Proposed High Wycombe South (Forrestfield North) Residential Precinct Local Structure Plan Amendment

Schedule of Submissions

Photo Plate 5

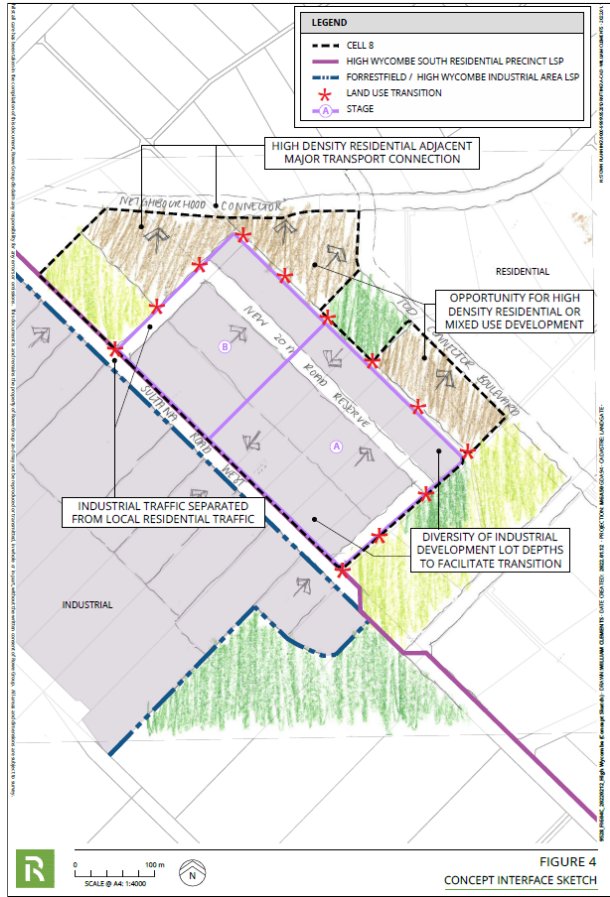
It is our position that the direct interface (being residential and industrial frontages to Sultana Road West), as contemplated by the Structure Plans, is an inappropriate land use interface and does not meet the objectives of SPP 4.1. Refer Photo Plates 2 – 5 demonstrating the scale of existing industrial development.

7. This matter is beyond the scope of the proposed LSP Amendment. Interfaces between residential and light industrial land uses is not uncommon across Perth and manageable through appropriate provisions of the local planning scheme, local planning policies and design guidelines. The Industrial LSP area shown on the District Structure Plan is zoned Industrial Development under the City of Kalamunda Local Planning Scheme No. 3, and does not meet the General Industry zone or Strategic Industrial zone definitions in draft SPP 4.1. Clause 5.2.1(c) of draft SPP 4.1 is therefore not relevant. See Submitter 8, Comment 6 above.

11. The modifications proposed by this Submission are reflected in Figure 3 – Proposed Structure Plan Modification.

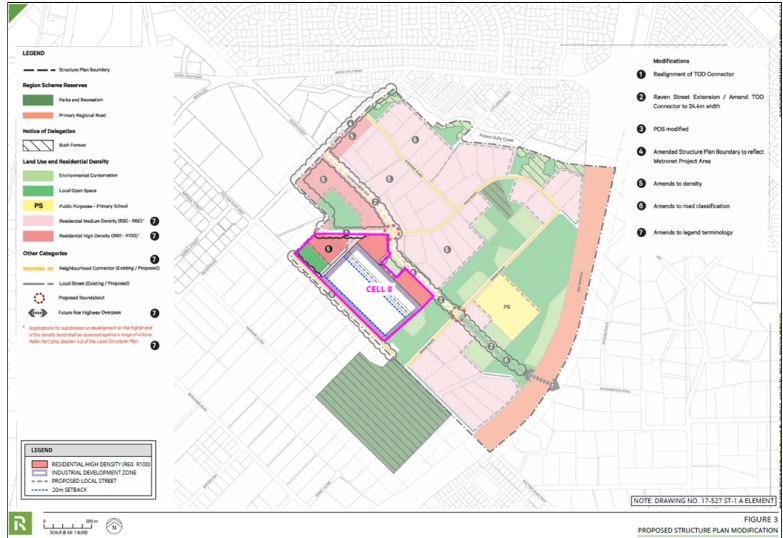
12. Further to this, it is requested that the following provisions are included within Part 1 of the Structure Plan:
4.2: Industrial Development Zone

11. Noted. See Submitter 8, Comments 4 to 7 above.

12. See Submitter 8, Comments 4 to 7 above.

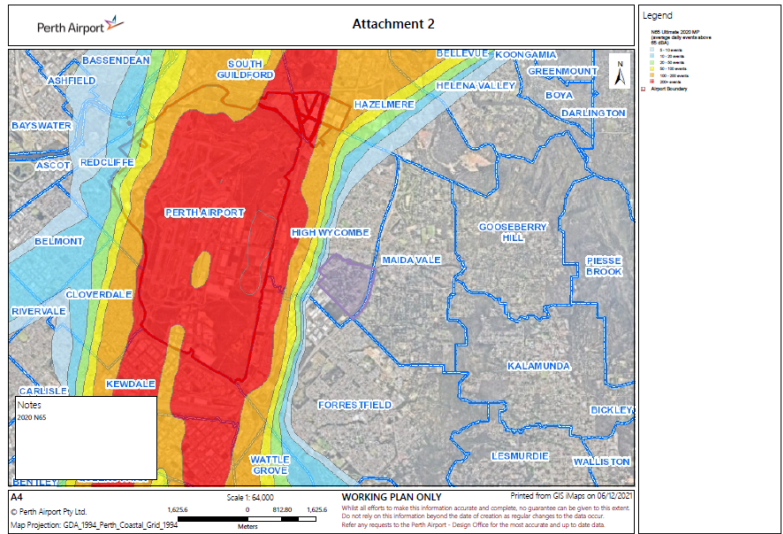
6. Using the NASF recognised N65 contour, the western portion of the subject site will experience up to 10 aircraft noise events above 65 decibels across an average day. Noise at this level is disruptive to a normal conversation even inside a dwelling and will be unacceptable to most people. It is worth noting that the area will receive a significant number of additional aircraft noise events at a level less than 65 decibels, and these noise events may also cause annoyance to some people. The N65 overlaid with the subject area is included in Attachment 2.

6. Noted. Assessment of transport noise will be assessed on a case-by-case basis at the time of future development, including assessment of aircraft noise pursuant to State Planning Policy 5.1 Land Use Planning in the Vicinity of Perth Airport, and potential attenuation measures.

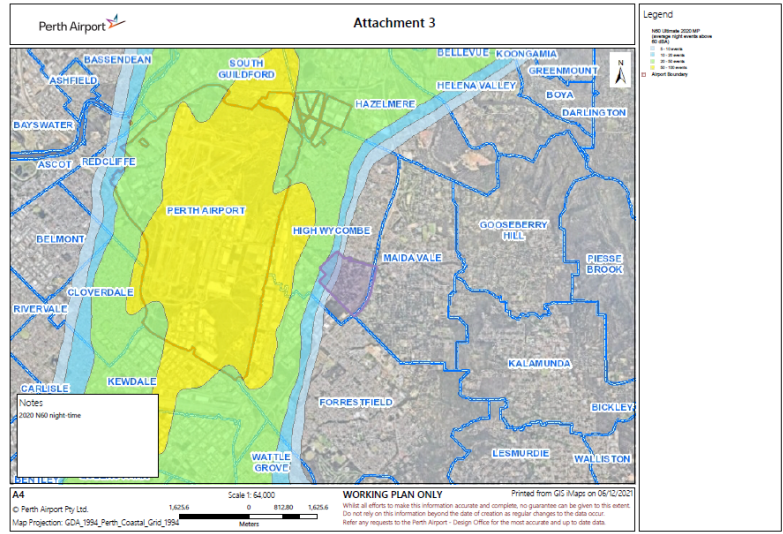
7. An additional NASF recognised noise metric is the N60, which shows the number of events in excess of 60 decibels that can be expected over an average night (11pm-6am). The lower threshold was chosen to reflect people’s increased sensitivity to noise in this period. The subject site will experience up to 20 aircraft noise events above 60 decibels across an average night. The N60 overlaid with the subject area is included in Attachment 3.
